Access Compliance Report

Public Rights-of-Way

Intersection ID: 11978	Main Street: WILSON_AV	Cross Street: BEAUX_ST	Location: E
ADA ID: 47998DE9E4DE	Ramp Type: BlendTrans1	Initial Pass/Fail: Pass	Overall Compliance: No
		Severity Score: 0

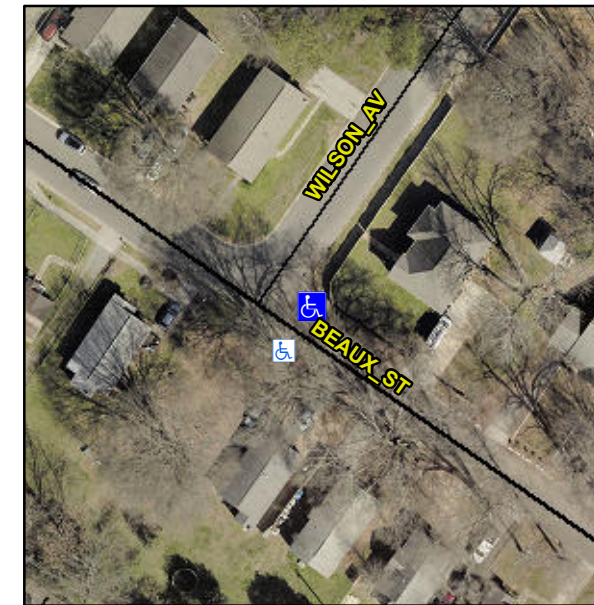
NO RT SW

Not Found, R305.2

Remove & Replace Curb Ramp With Two New Directional Ramps or Equivalent.
